City of Ketchum

CITY COUNCIL MEETING AGENDA MEMO

Agenda Item: Recommendation to implement Year Two traffic calming pilot project in West Ketchum.

BIRD DRIVE TRAFFIC CALMING TEST

BIRD/WOOD RIVER DETAIL

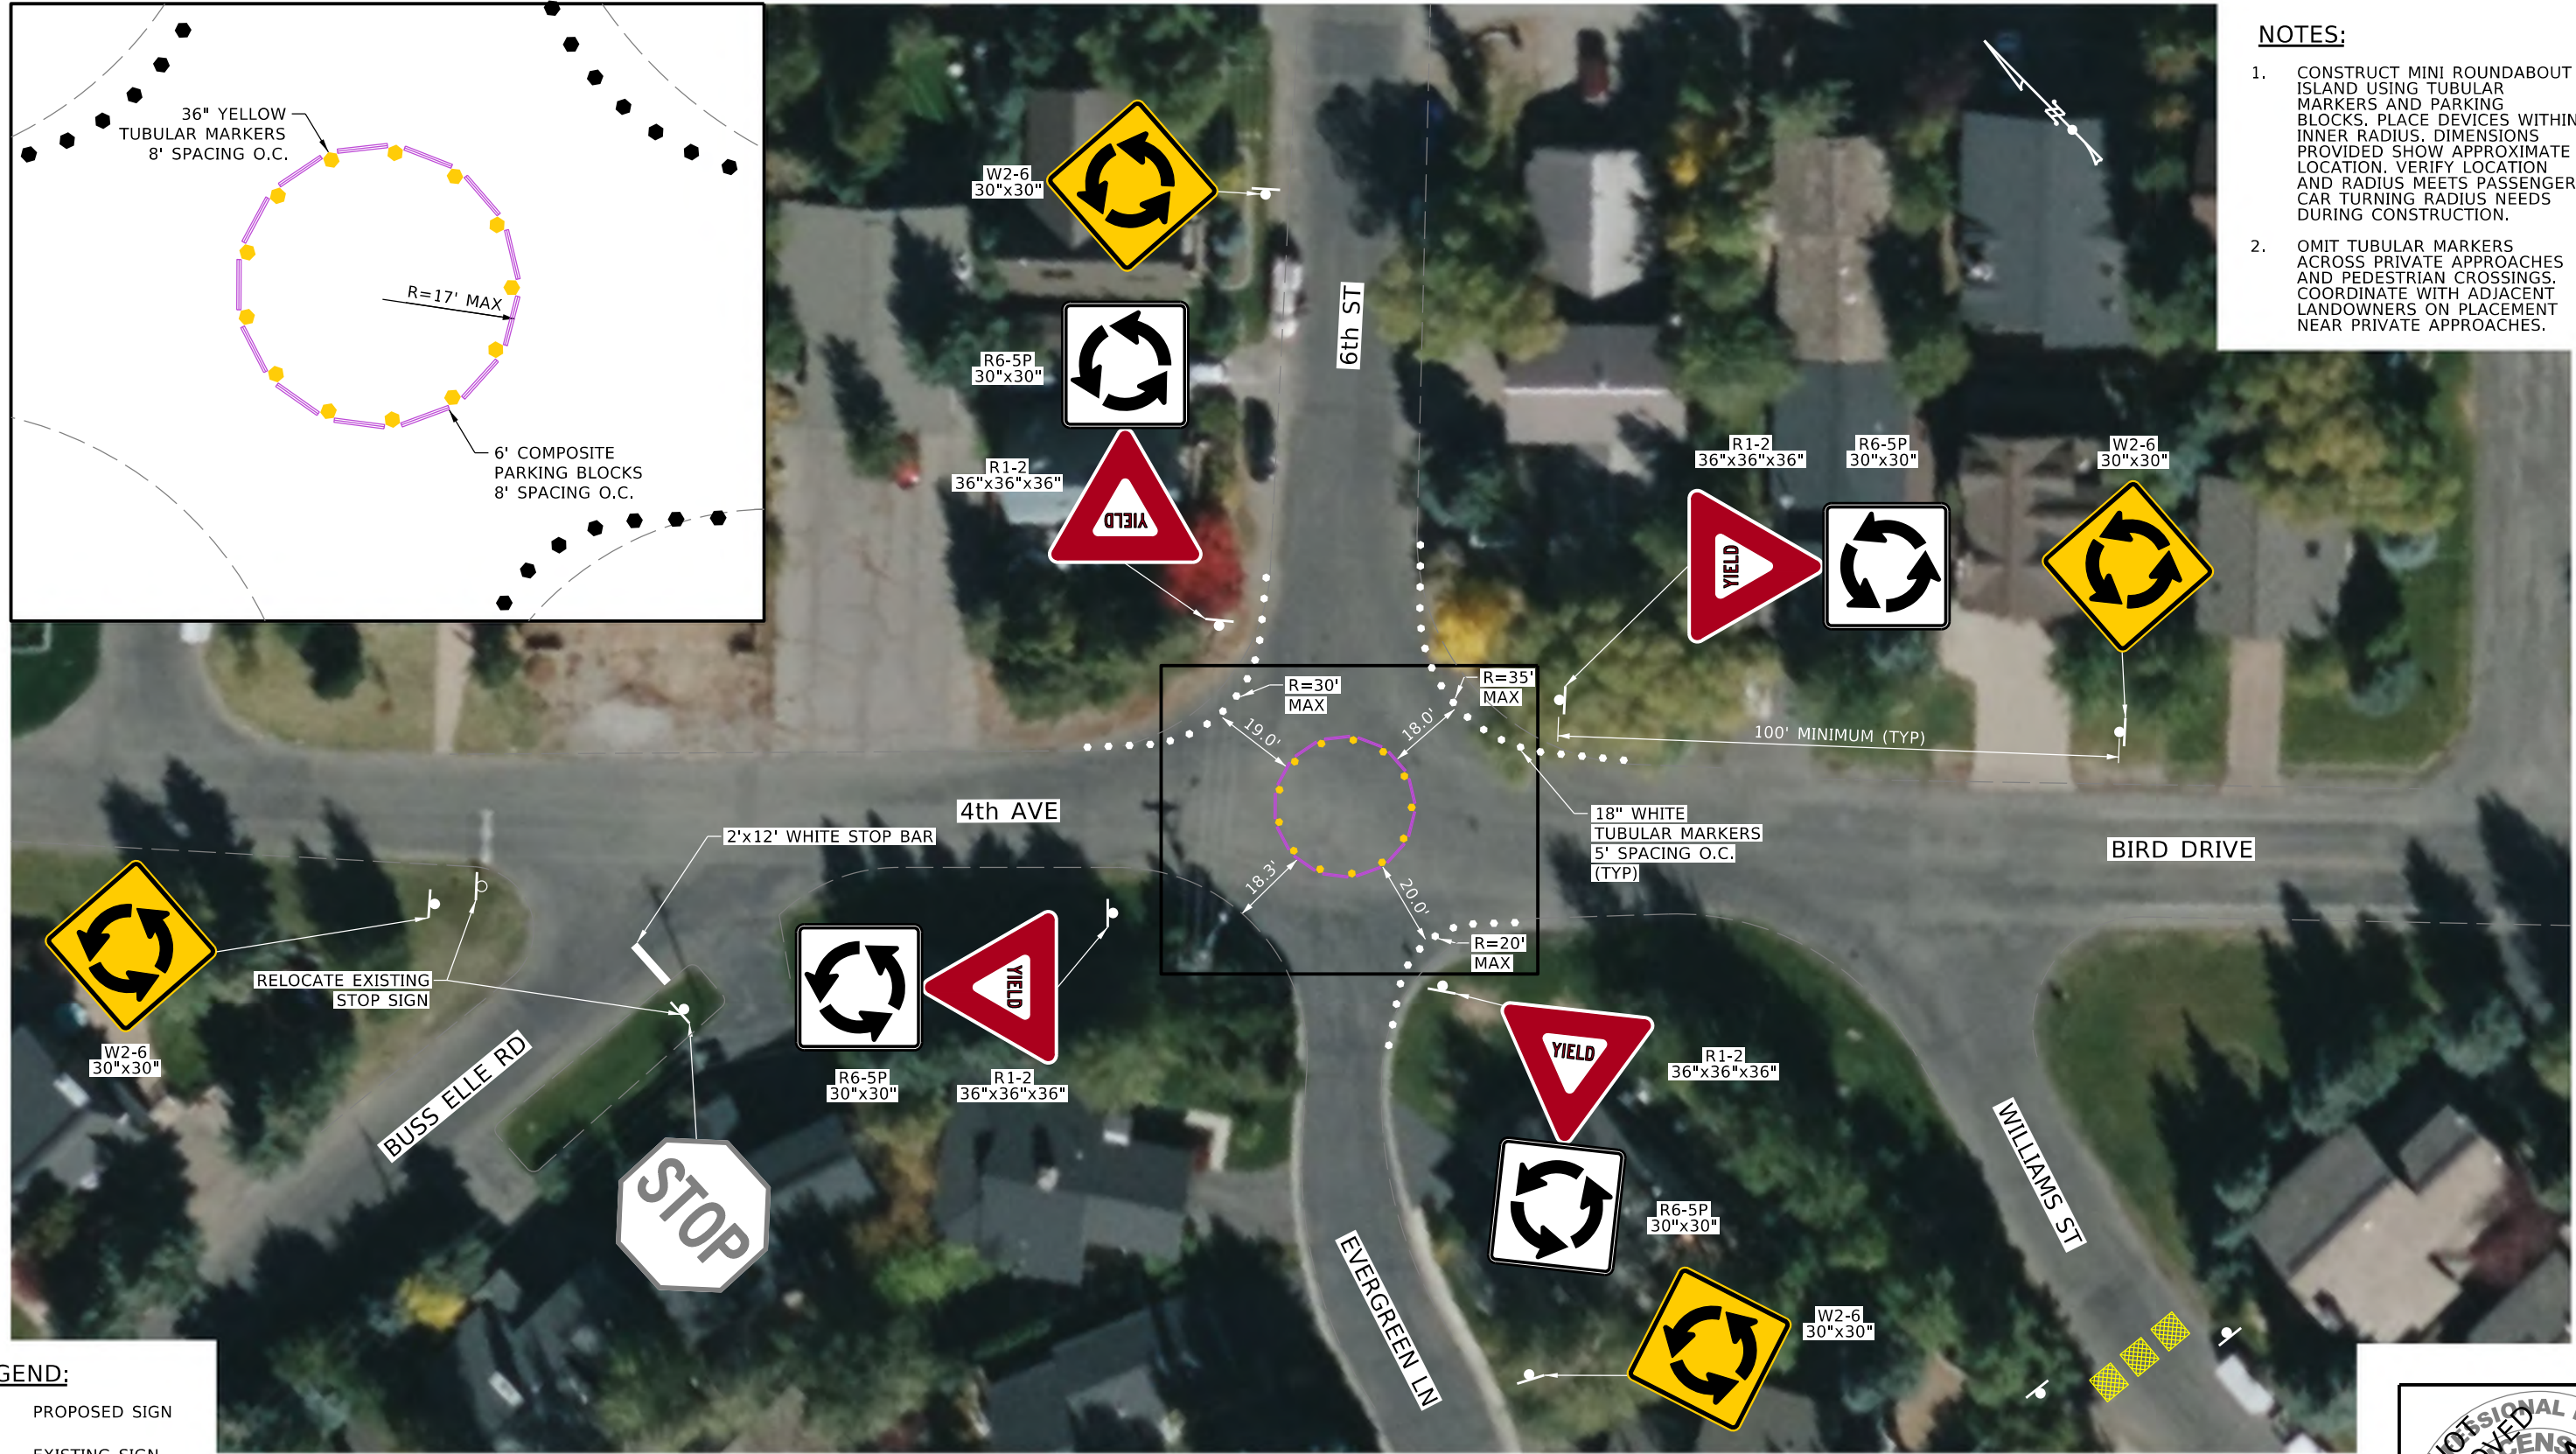
And finally, I'm still unclear as to the purpose of crosswalks at the intersections of Bird and Wood River Drive. No pedestrian has ever used those, based on the thousand times I've walked my dog past there in the last months. From what I can tell, the folks who live in the condos/townhomes at that intersection would love a way to get cars to slow down when they go around the bend on WRD heading north/northwest or south/east. There have often been homemade sandwich boards there that beg drivers to slow down and, as a frequent walker, I can concur that vehicles take that corner (especially when heading north) way too fast, probably due in part to the slight downhill there.

The crosswalk at Bird and Wood River has way too many tubular markers glued to the street this is an eyesore for West Ketchum.

MINI ROUNDABOUT DETAIL

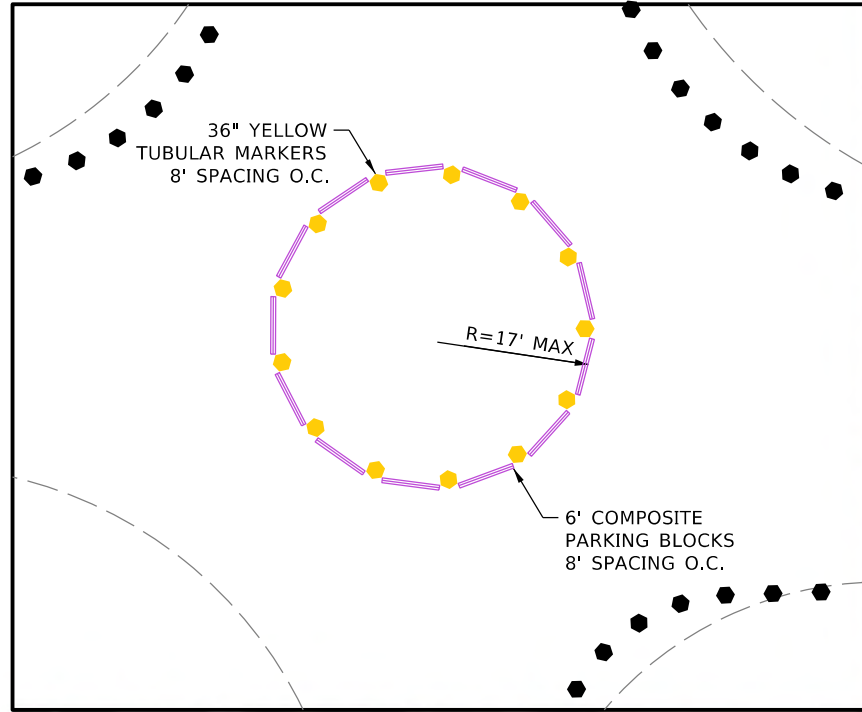
First and foremost is the “temp” roundabout that was installed at the end of Sixth Street...at first we thought it was a joke, but then quickly realized that it was for real ... WOW ... then we proceeded to watch the traffic get completely confused and large trucks with trailers and RV’s have great difficulty maneuvering around that “roundabout”???. Now, I am familiar with using roundabouts and that location does not have the room for a proper roundabout, not to mention that there is not really enough continuous traffic to justify a “ real life” roundabout. In addition to the awkward use of that insurrections temp roundabout, the center seemed to attract a lot of neighborhood use for kids to play in the middle of the street and adults to have their cocktail parties and lounging parties also in the middle of the street. At some point some random car or truck will lose control and likely drive right through the middle of that party center roundabout and kill or seriously injure someone that then the City of Ketchum will have it’s hands full of legal liabilities.

In my opinion what has been done and what is proposed to be continued is a “lotta notta” there is no real traffic issue at the bottom of Sixth Street and the current traffic pattern works without the “roundabout”

I feel unsafe using the traffic circle because (likely) those same speeders abuse the round a bout.... And cut through the wrong way on the round-a-bout.

There should not be a round-a-bout. Use the same crosswalk type enhancements as is being put on Wood River.

Next, I don't see the value of a roundabout, but clearly it became a community hub, of sorts, so in that way I guess it's nice to have. Anecdotally, I have not noticed any difficulties at that intersection over the winter, traffic-wise, after last year's roundabout was removed.
